## Product Change Notice (PCN)

**Subject:** Part Marking Change for the Listed QML Products

**Publication Date:** 4/27/2018

1. ISL70040SEHVL GanFET Low Side Driver

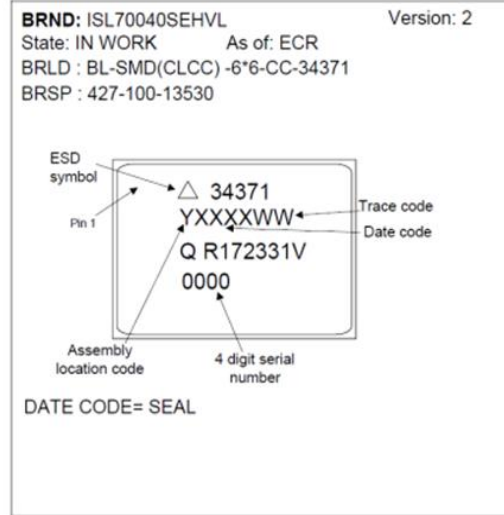
Before

After

2. ISL73040SEHVL GanFET Low Side Driver

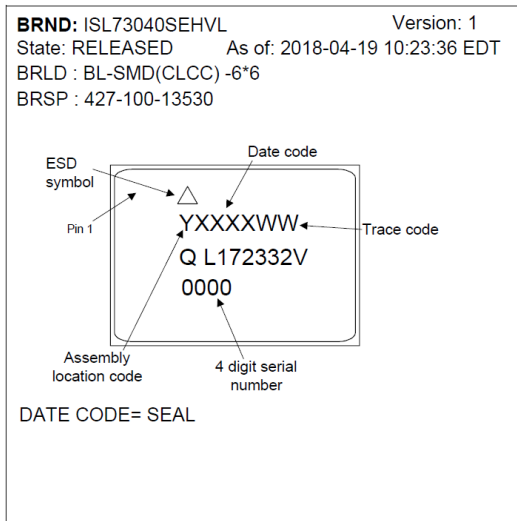
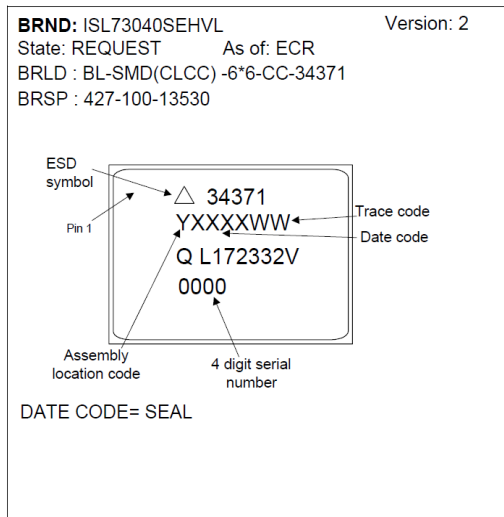
Before

After

4. ISL75051ASEHVFE 5V LDO

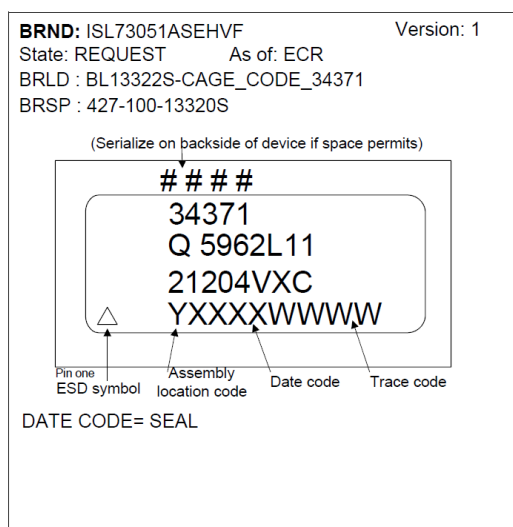
Before

After

6. ISL73051ASEHVFE 5V LDO

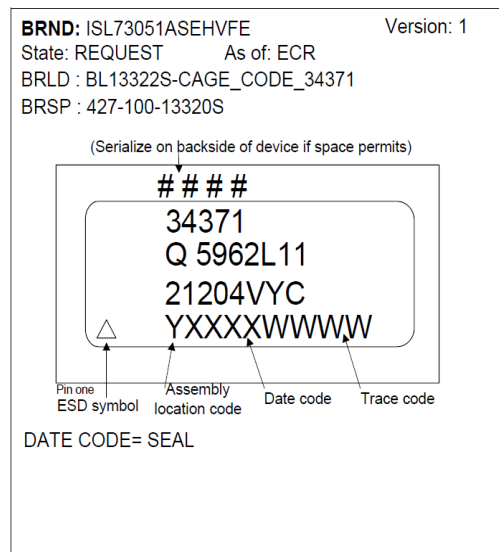
Before

After

7. ISL73321SEHVF Quad Sequencer

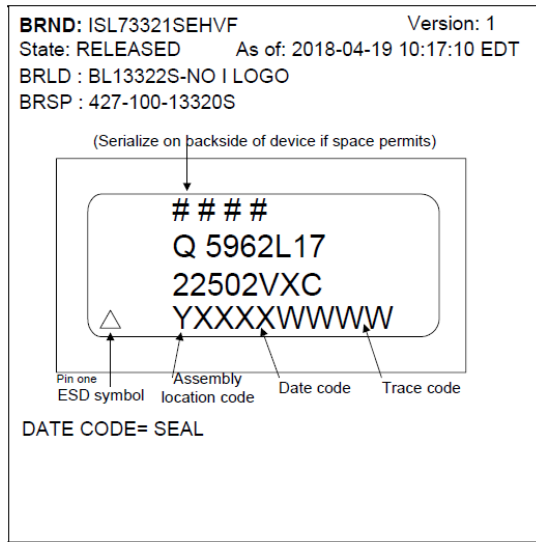
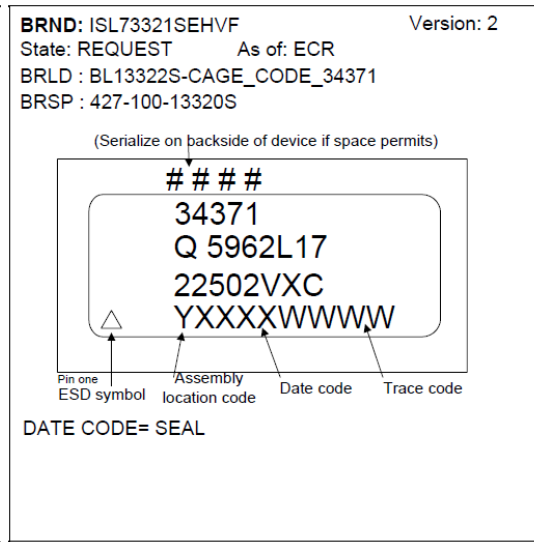
Before

After

8. ISL70321SEHVF Quad Sequencer

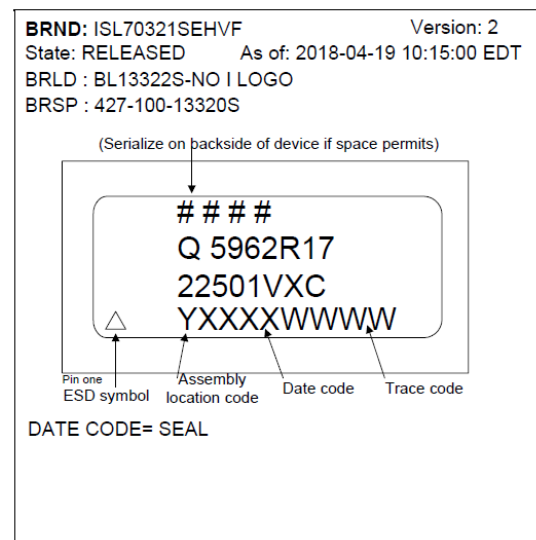
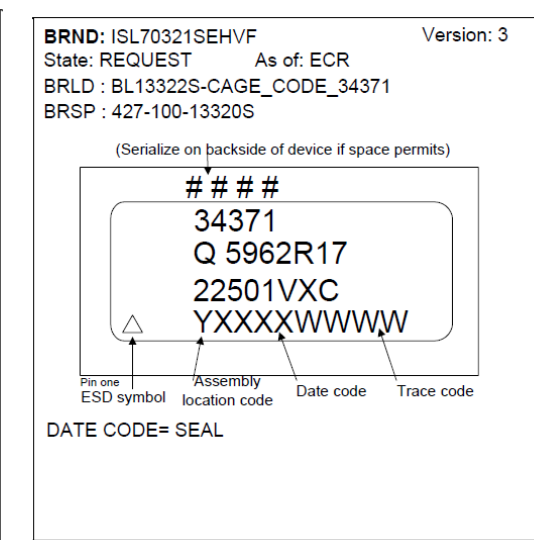
Before

After

9. ISL72813SEHVL Current Driver

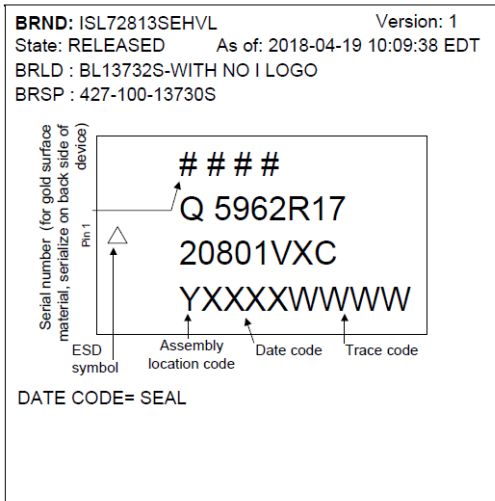
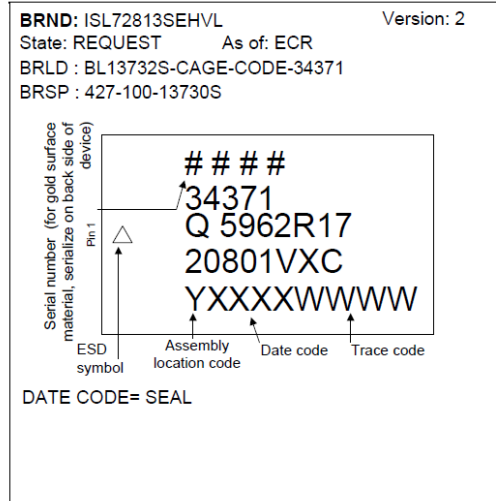
Before

After

10. ISL71590SEHVF Temperature Sensor

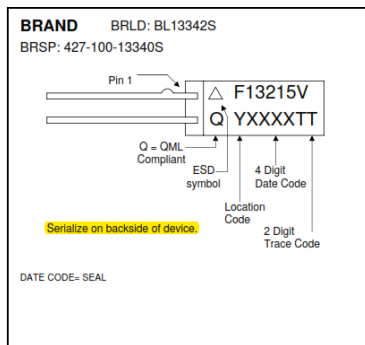
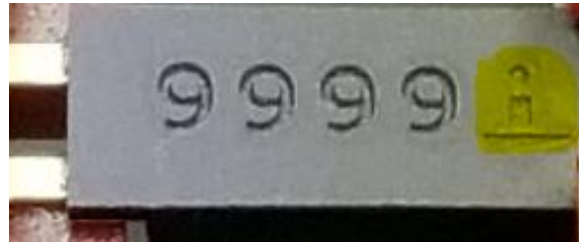
Before

After: (logo will be on the backside with the serial number)

11. ISL73590SEHVF Temperature Sensor

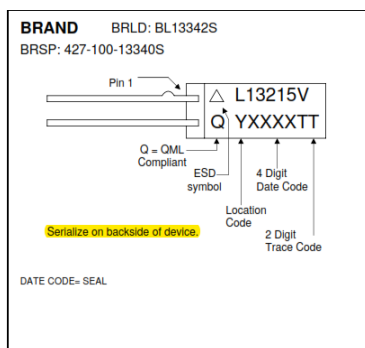
Before

After: (logo will be on the backside with the serial number)
